## RAI 361 S1 (Q9.2.2-97 – Section 9.2.8)

**Request for Additional Information No. 361, Supplement 1**

**U.S. EPR Standard Design Certification**

**SRP Section: 09.02.02 - Reactor Auxiliary Cooling Water Systems**

Figure 2.7.2-1—Safety Chilled Water System Functional Arrangement  
Sheet 1 of 4

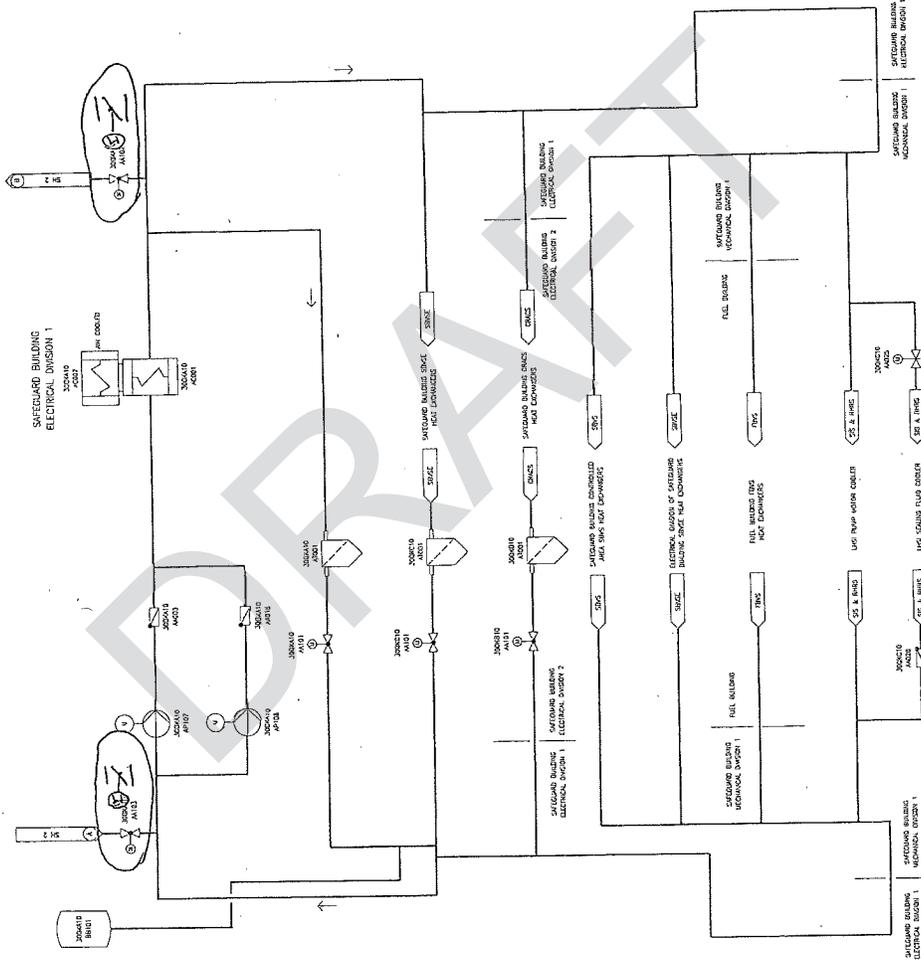
*Revised IAW RAI 361 Q 08.02.02-95C*
